Anna Gamble – 146 Trinity Point Drive, Morisset Park

LANDSCAPE AND VISUAL AMENITY ANALYSIS

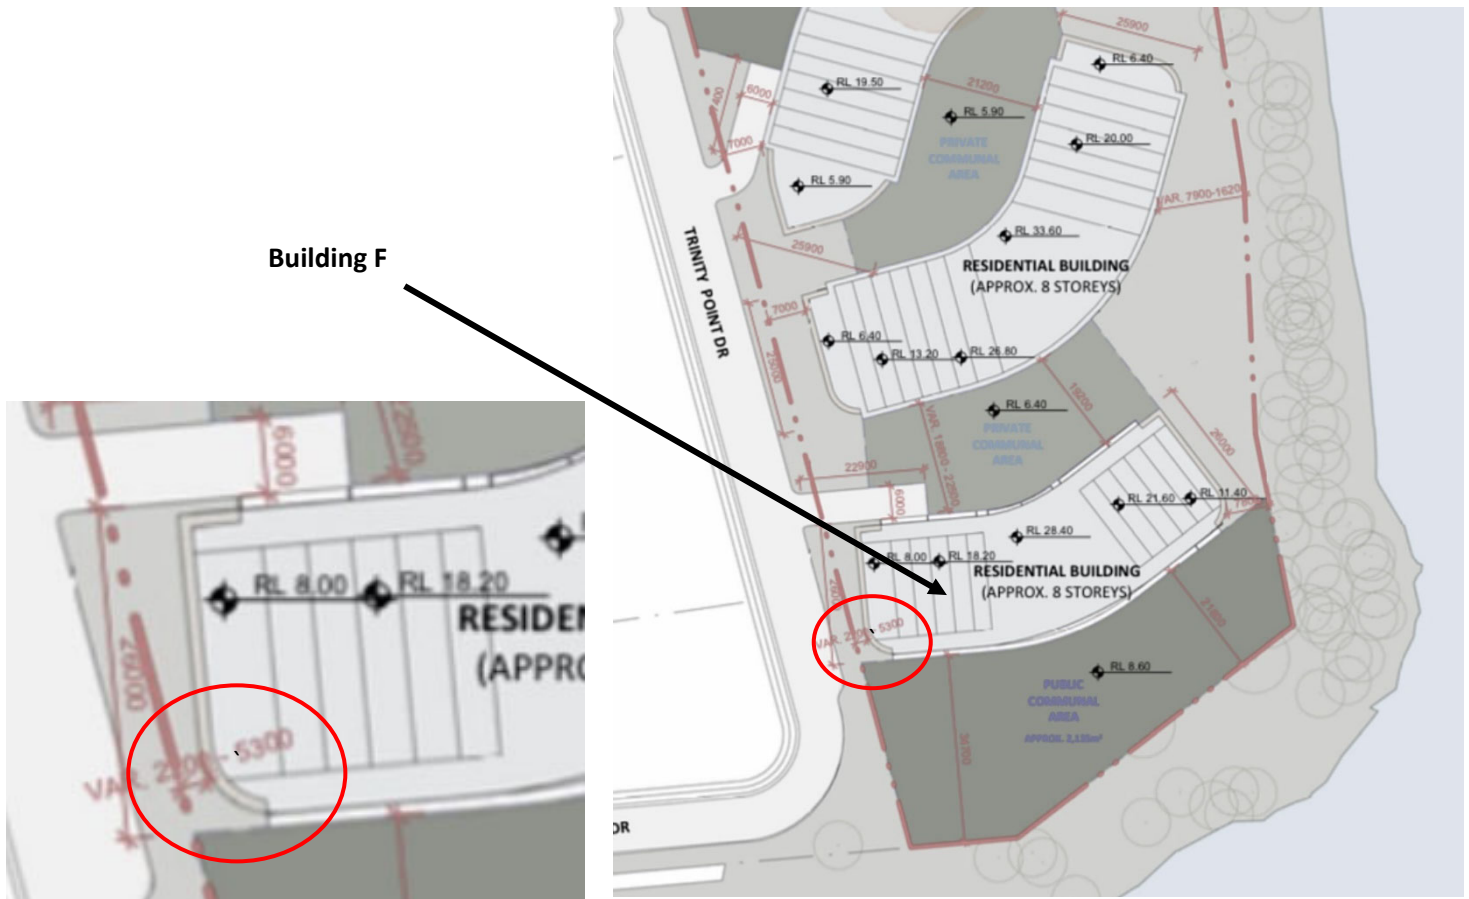
2. Non-compliance with Street Boundary Setback of 'Building F' with the Lake Macquarie Council Boundary Setback requirements for Residential Flat Buildings (sec 13.1 of the DCP).

The proposal shows Building F within 2.2 m of the Trinity Point Dr boundary. This is completely inadequate for the reasons outlined below:

The Council then states in its Controls, that the building must be setback a minimum 6 and maximum 8 metres from the street boundary. Further, it is clear from the DCP, that the council intends to set a consistent setback standard and define a consistent edge for the street. This proposal shows Buildings D and E setback 7 m from the street. The setback of Building F which is 2.2 metres at the closest corner runs foul of these guidelines and directly contravenes Council's DCP requirements in relation to this issue. It should be noted that the Council's guidelines specifically state "minimum 6 metres". We understand that 6 metres is not a distance for an average of variable setbacks. It is a minimum setback of the part of the building that is closest to the street boundary. In the case of Building F, its closeness to Bluff Point and matters raised in point 4 and 9 of this document create a strong case for the closest point of the building to be further than the maximum 8m setback nominated by the Council for standard Residential Flat developments.

The setback for building F is shown below:

In conclusion, Building F should be set back a minimum of 8-10m from the closest point to the boundary, in recognition of Council's guidelines on setbacks, the proximity of this building to Bluff Point, the need to provide room for additional planting as discussed in point 4 of this document (see below), and to provide more space around this iconic and unique structure as per point 9 of this document.

The evolution of the Trinity Point Hotel. 1. Currently approved DA, 2. Initial Koichi Takada proposal, 3 Current proposal. Source: JPG

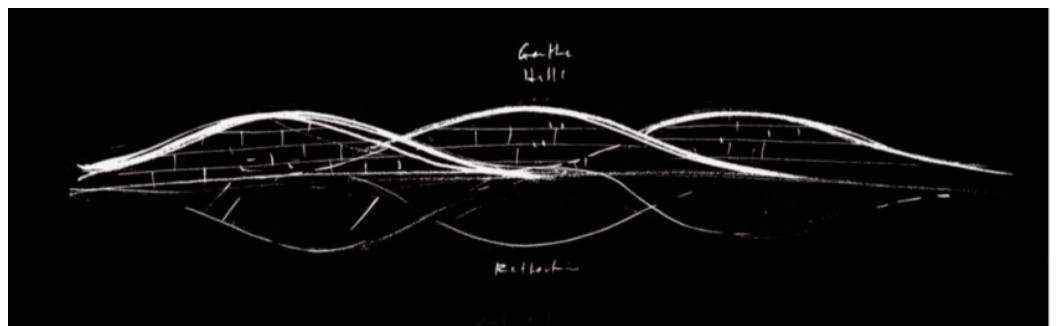
Sadly, this project has moved from mostly 4 storey development to mostly 8 storey development with no doubt, a further 2 storeys to be added in the future within the proposed beautifully glazed 8 metre tall roofspaces of the buildings, making these buildings essentially 10 storey structures.

It is hard to know how much further in the name of economic gain this development will still be pushed through variations and concessions to increase the yield from this site, that is no doubt still to come. What is certain, is that this concept has moved way away from architect’s original vision of gently rolling hills.

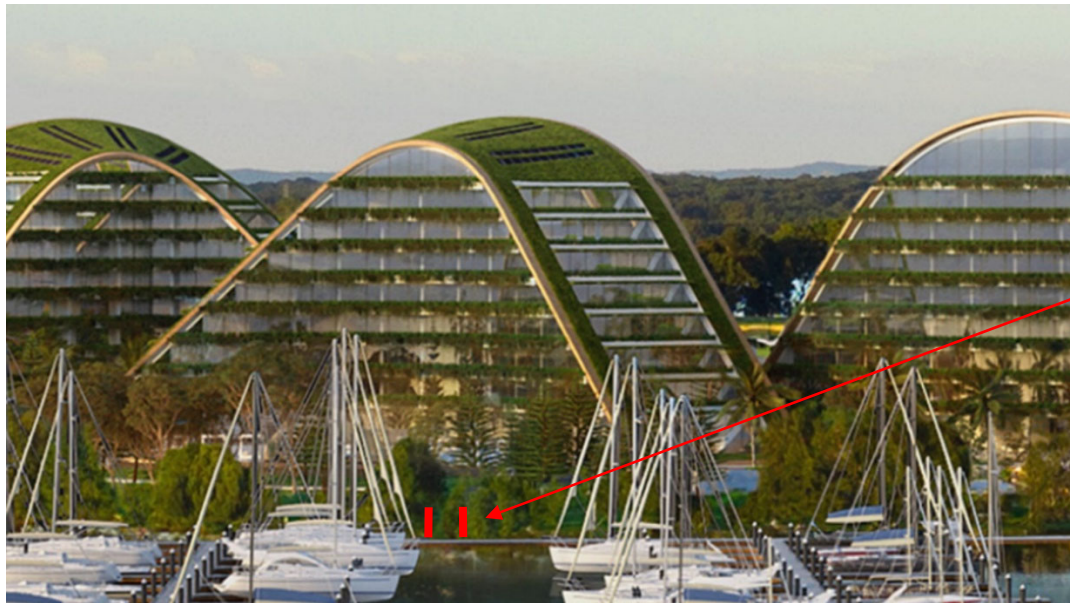
For most part, the visuals/renderings provided with this proposal are vertically compressed and do not give a true impression of the heights and bulk of these buildings. And they lack context – human context, which is the only way that the bulk of these buildings can properly be judged.

Under this proposal, these gigantic buildings are located right across the road from two storey townhouses with block widths of just 4 m each. They neighbour and overlook modest 1-2 storey family homes which will forever see the hulking structures towering above them. Most residents will no doubt wonder how such out-of-scale gigantic structures were ever able to be constructed in this quiet regional area. Simply put, at the present heights and footprints, this development is grossly overscaled.

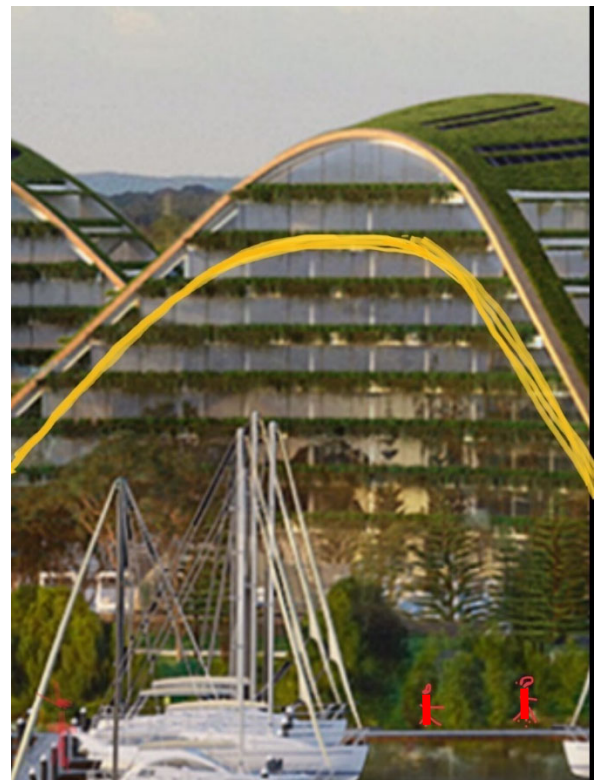
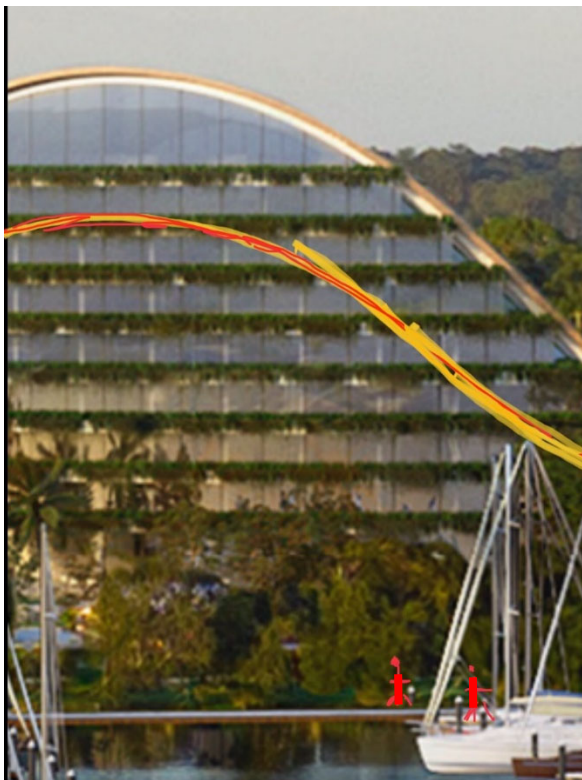
It should also be noted that all of the land at Trinity Point was sold by the Proponent at premium prices, with the approved DA design for the precinct setting the expectation of the overall amenity of the area, based on well spaced, medium rise buildings. The proposed buildings with their bulk and height would be more appropriate in an area that already has high rise buildings, like Green Square in Sydney, than in an area adjoining predominantly 1-2 storey single dwellings.

The above hand drawn illustration show a reduction of building height by two residential floors and that such a change would yield buildings that are much more proportional to their environment.

In summary, the proposal would greatly benefit with reduction of two floor heights, or around 6-7m height reduction, and a corresponding reduction in footprint of the buildings. Looking at the conduct of the project to date, and the matters raised in point 10 below, it is likely that the Proponent will put in some residential space into the 'Roof Feature' which is fully glazed and stands at 8m high. Reduction of the building height by 2 storeys would still allow construction of these buildings essentially to 8 storeys.

Impact of the development on the foreshore area: DA Approved vs. Current Proposal. Source: Base image: JPG (cropped image 1 and 4 above), rendered by A Gamble.

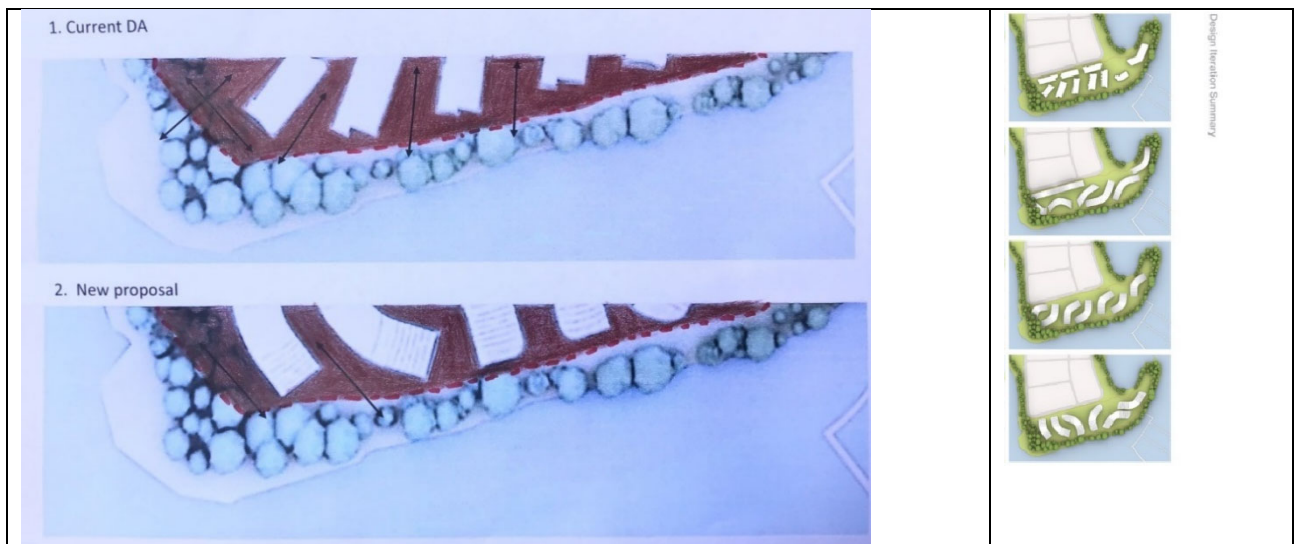
Under the new proposal, the amenity of the foreshore area is significantly reduced. The new proposal has much less open space within the proponent's boundary on the foreshore side, as illustrated by the amount of coloured-in area (in brown) in the visuals below.

The new concept lacks the long views into the site of the original proposal, which make these oversized buildings even more problematic.

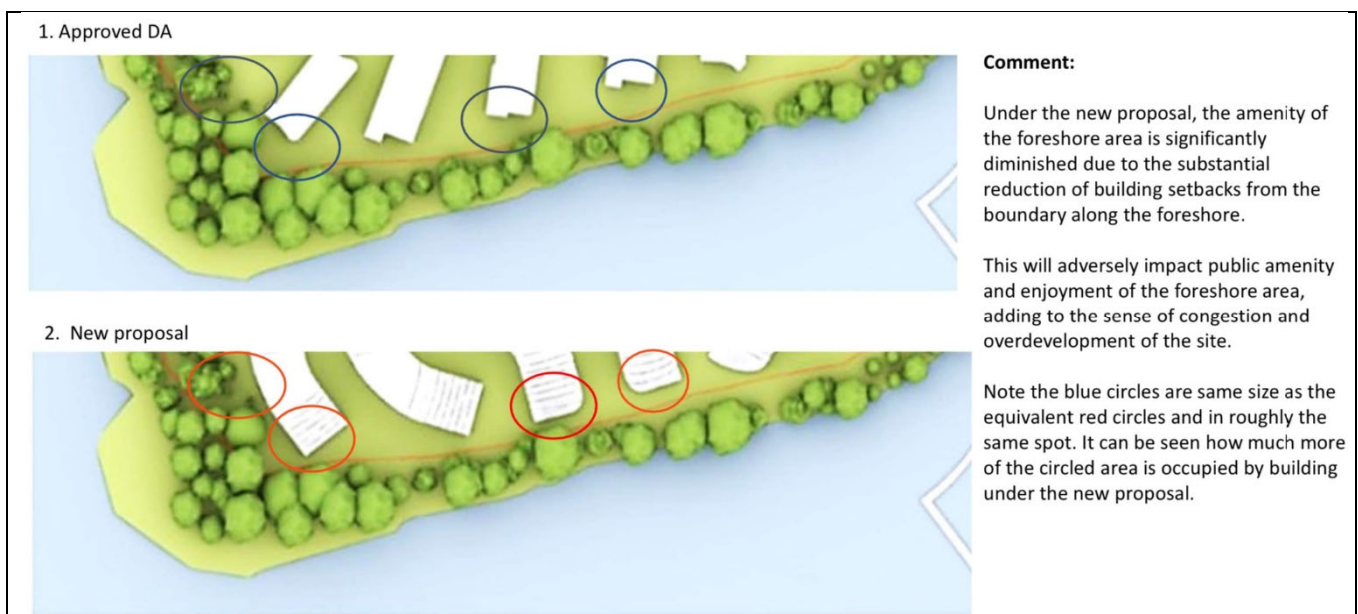
The visual below shows the reduction of foreshore setbacks from the current DA and now to the new proposal.

The new proposal features much smaller building setbacks along the foreshore boundary, which together with the oversized building footprints and much greater building heights, will potentially make foreshore users feel that they are sandwiched between the massive development and the massive lake.

To resolve this issue, reduction in building footprints should be considered, together with a reduction in heights, increased setback from the foreshore and improved spacing between the buildings.

Image 7: Key Wind Flows Expected On the Proposed Development Site

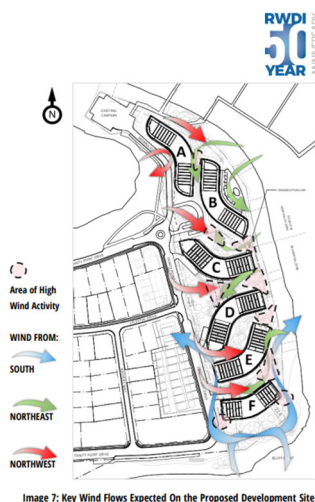
The wind flow analysis does not seem to have considered impact on our property – only the development itself. It acknowledges that the corner of Building F, which is only 20 m from our boundary, will experience increased wind activity during summer. No mitigation measures are proposed.
